Preferred Project Report for the

Liverpool Hospital Concept Plan Application

Liverpool Hospital Redevelopment
Preferred Project Report

2.0 Schedule of Issues and Responses

Fig. 01 - Scope of Early Works

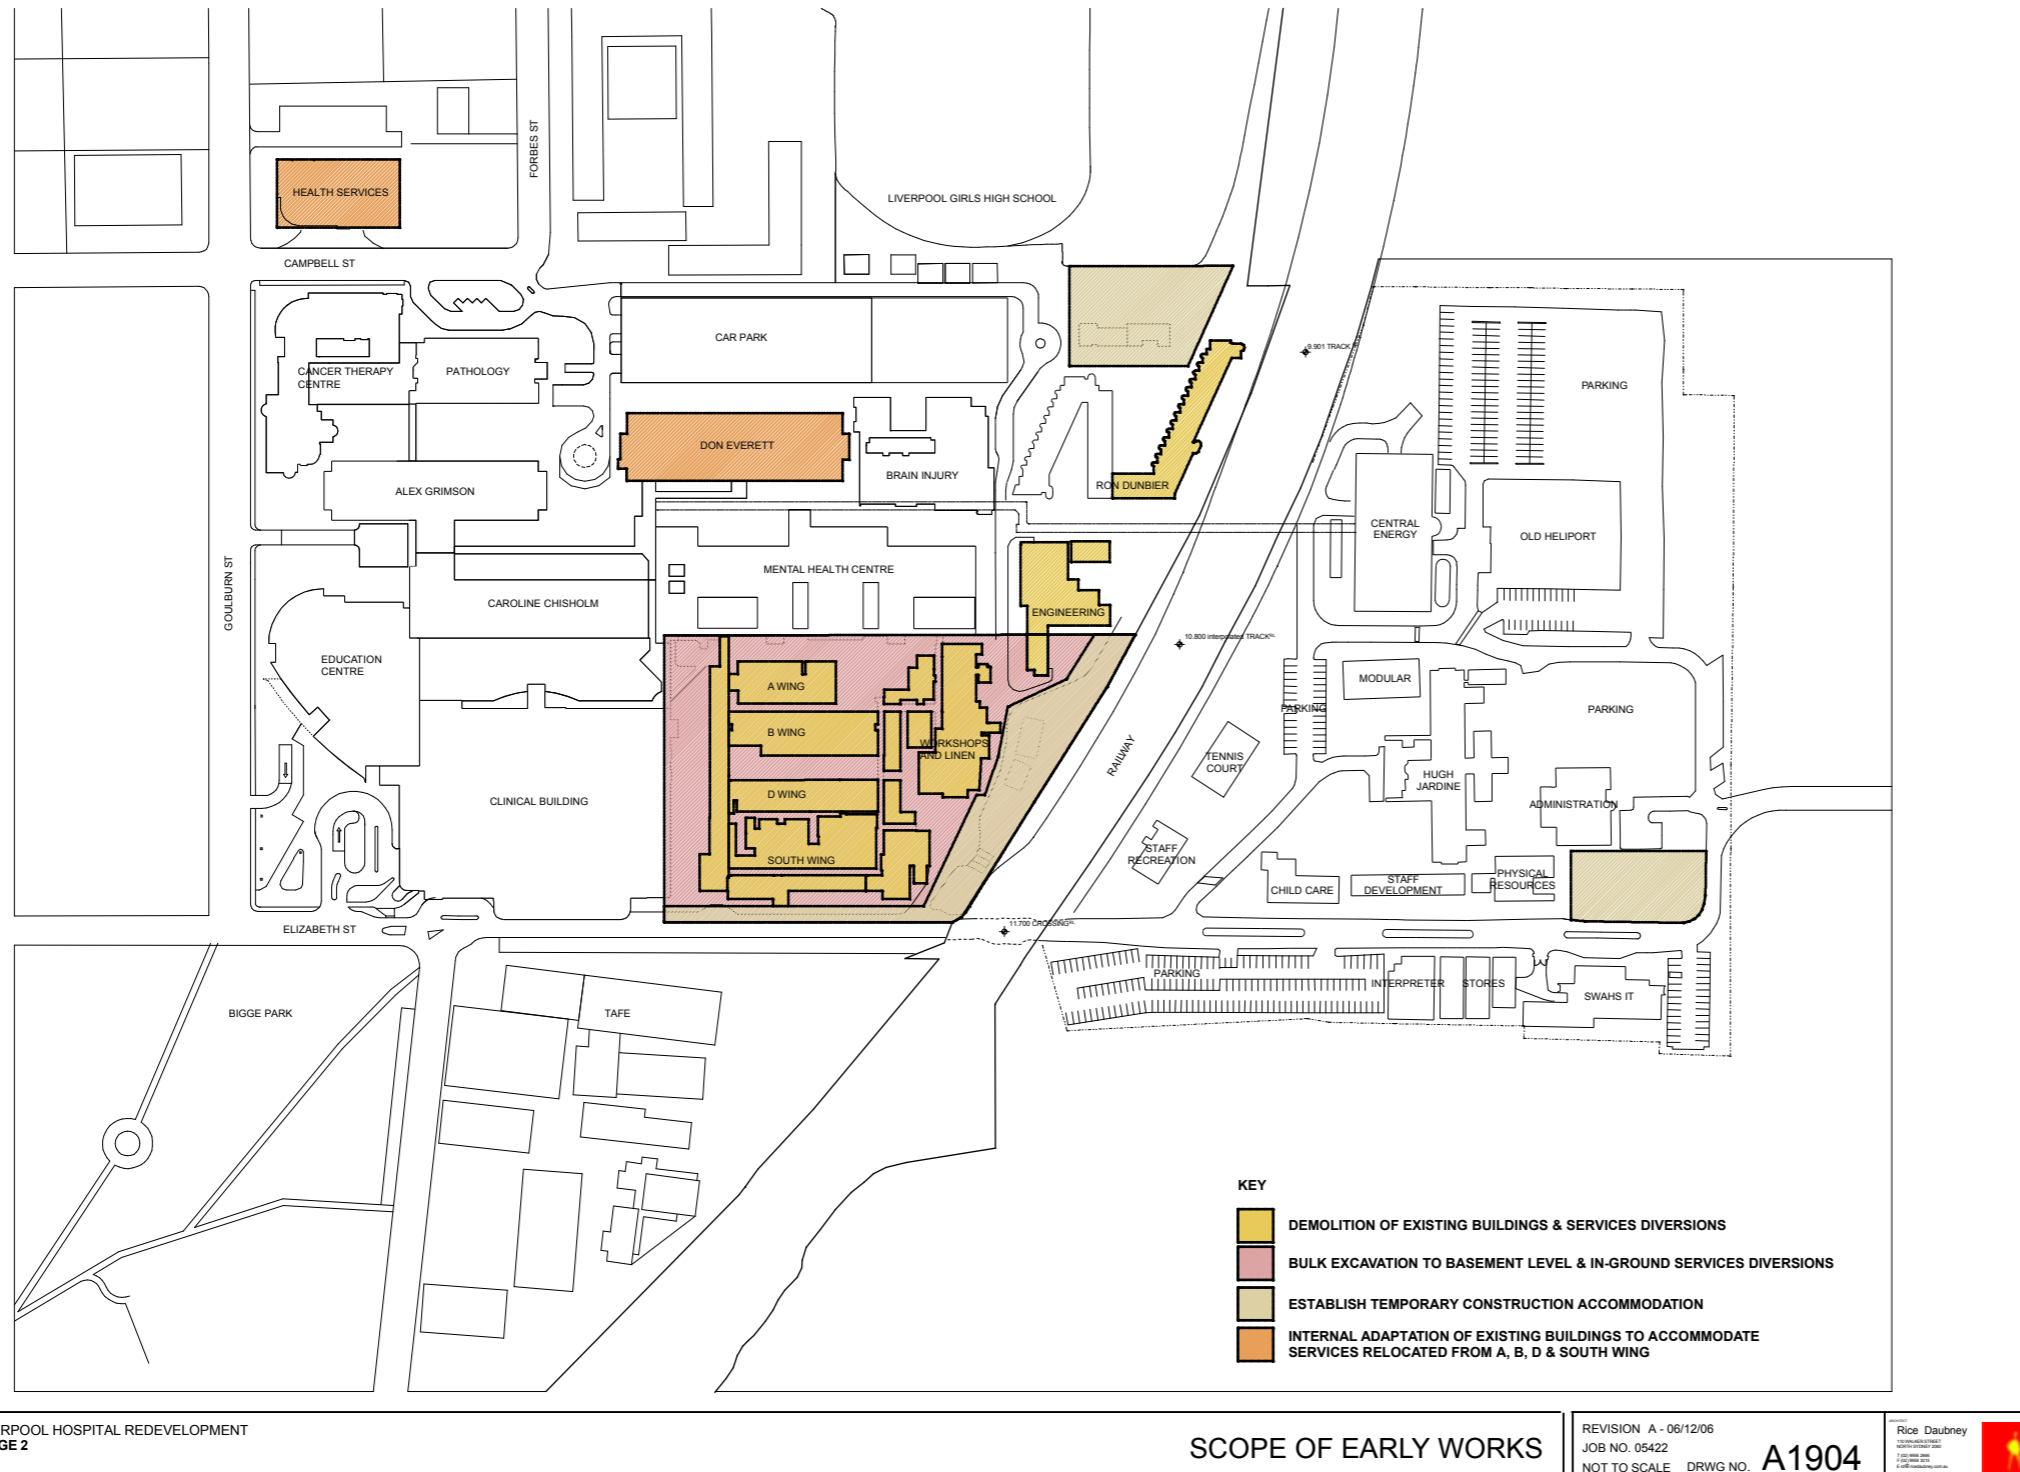
Issue	Response
<ul style="list-style-type: none"> Early Works & Future Approvals Section 1.6 of the Concept Plan (page 9) seeks approval for 'early site preparatory works and detailed excavation and structural works up to ground level for the new eight storey core hospital development'. Clarification is sought as to whether these works are intended to form part of a Part 3A project application or is approval being sought through Section 75P(1)(c) of the Environmental planning and Assessment Act, 1979 (the Act). 	<p>Approval of early works is sought through Section 75P(1) of the EPA 79. The scope of the Early Works comprises the works as shown by plans A1904, A1905 and A1906 (refer 3.2 Figs. 04-06). The works include services diversions and relocations, heritage and archaeological assessment and management, demolition and excavation in development zone A and structural works to ground level in development zone A. Refer to Section 3.2 for additional detail.</p>

The scope of the Early Works comprises the works as shown by plans A1904, A1905 and A1906 including:

- Identification, diversion, relocation and reconnections of existing reticulated services (in-ground and above ground), that will be impacted by the demolition of existing buildings and/or the earthworks excavation as indicated by the plans.

- Demolition of buildings as shown and construction of new façade/services wall for the western wing of Ron Dunbier accommodation building. Buildings to be demolished include South Wing, B Wing, D Wing, corporate services linen and workshop buildings, engineering offices, workshops and sheds, interconnecting corridors and Ron Dunbier eastern wing.

- Structural works to ground level including piling and piers, slabs and columns.

Fig. 04 - Sketch Montage - View from TAFE site

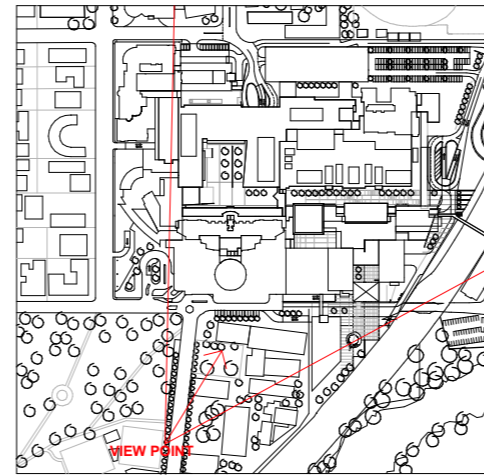
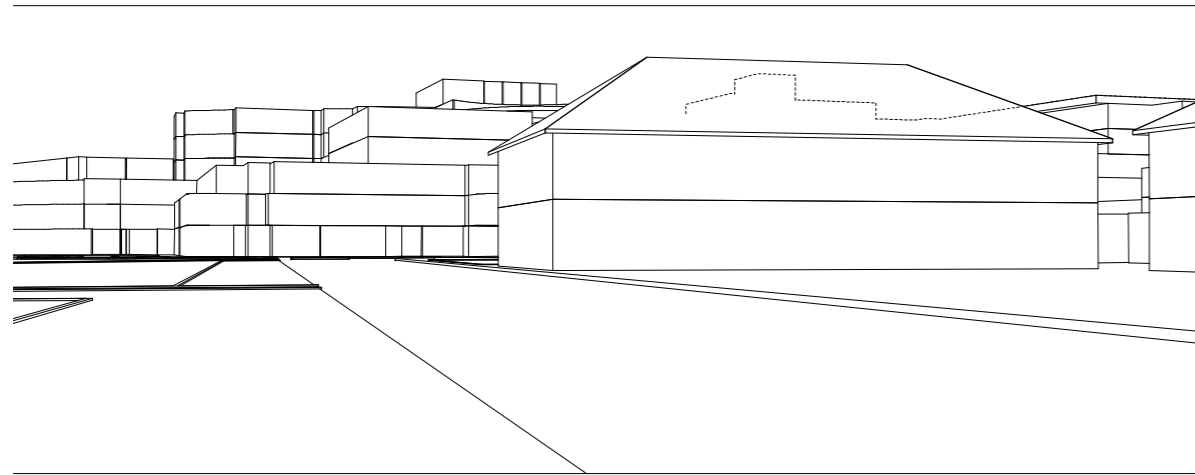
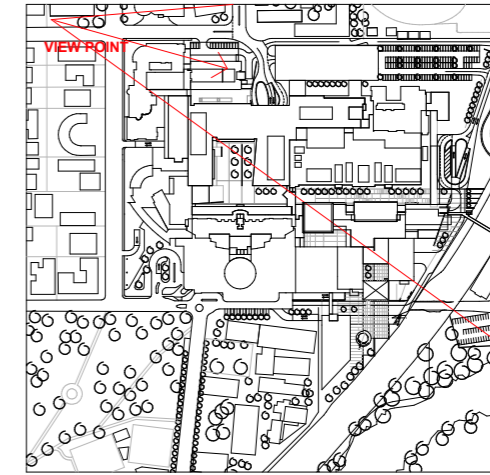
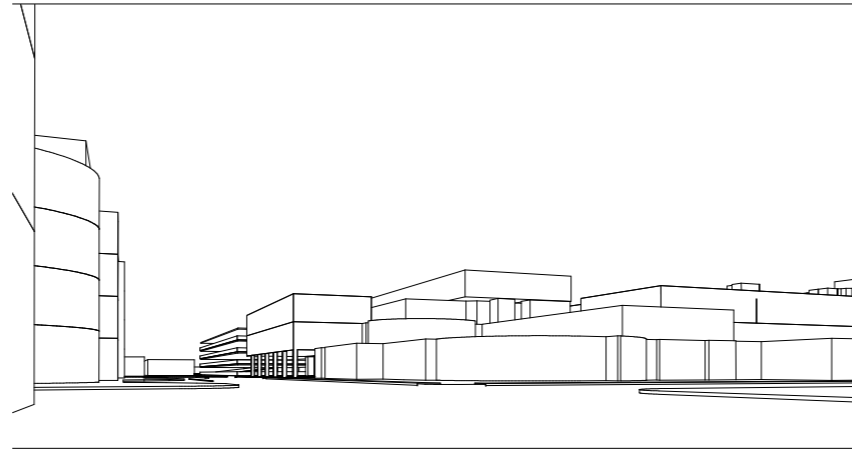
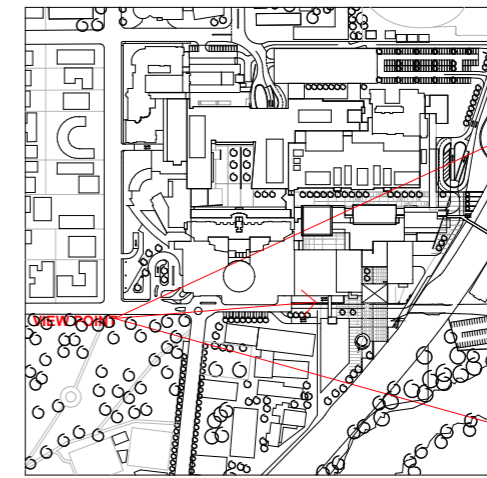
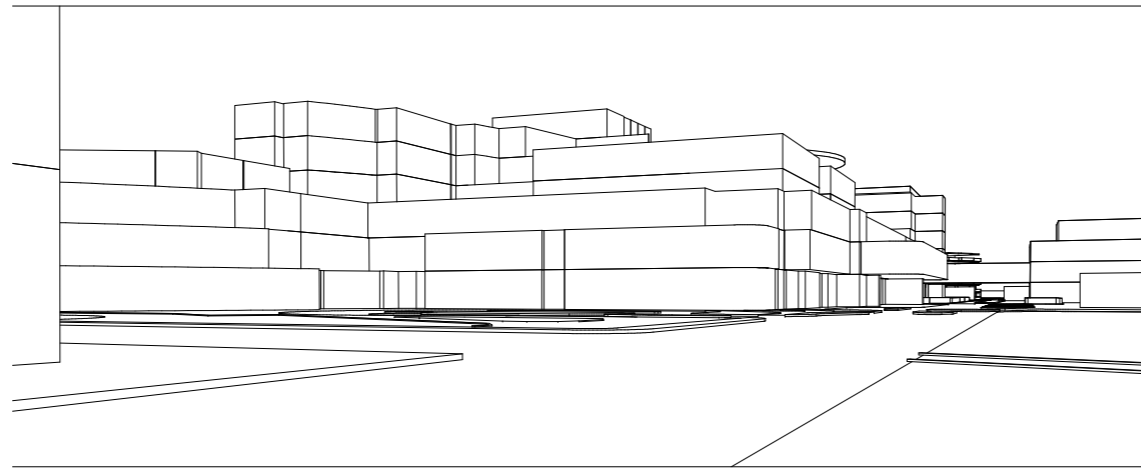
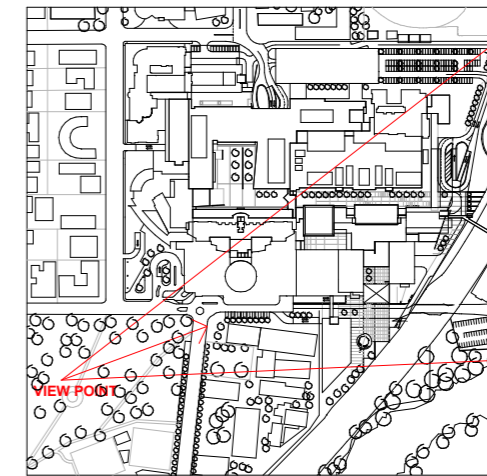
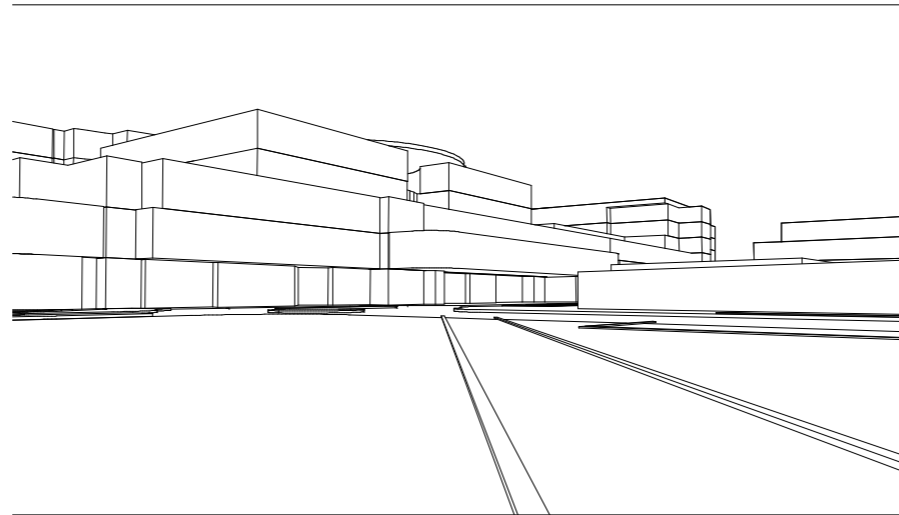
<ul style="list-style-type: none"> Detailed visual assessment should be undertaken and include realistic photomontages of the proposed buildings. 	See above.
				<ul style="list-style-type: none"> Existing heritage assessment is not sufficient to justify any new development within the proximity of the TAFE buildings. More detailed heritage assessment should be prepared to assess the impacts of the proposed four storey structure at the north east part of the TAFE site. 	The Heritage significance of the TAFE complex has been carefully considered. The project Heritage consultant was responsible for the preparation of the CMP for the TAFE sight and had regard for all the relevant issues in the final recommendations for limited development within the TAFE site which is an integral part of the Concept Plan. Commitment to undertake additional heritage assessment within the north eastern sector of the TAFE site as part of the Project Plan Application.

<p>All additional plans should be produced at an appropriate scale (A1 size or similar) and encompass both the Liverpool Hospital site and the surrounding area in order to show the context of the site in the immediate locality. The plans will ensure that the Department can carry out an accurate assessment of the Concept Plan proposal.</p>	<p>Noted.</p>
<p>It is requested that a detailed visual analysis be produced from a range of public vantage points so as to clearly show the bulk, scale and interface between existing and propose built development particularly proposed heights and setbacks. As a minimum photomontages should be submitted to show panoramic views from Bigge Park, the TAFE site and Campbell Street.</p>	<p>A series of visual analysis drawings have also been prepared showing views from TAFE , Campbell Street, Elizabeth Street and Bigge Park (see Fig. 04, 05, 06 and 07). Also refer to Section 3.5 for further detail.</p>

A series of visual analysis drawings have been prepared showing views from Bigge Park, outside the TAFE college on the western side and Campbell Street with the proposed building development envelope outlines overlaid, (see Fig. 04 - 07). These drawings indicate clearly that the proposed development will have only minor, and in some cases negligible, visual impact from these strategic viewpoints. In regard to the TAFE college site, the proposed TAFE car park site development will not be visible from Bigge Park or outside the TAFE college. The roof line of the proposed TAFE car park site development is behind and obscured by the existing TAFE buildings.
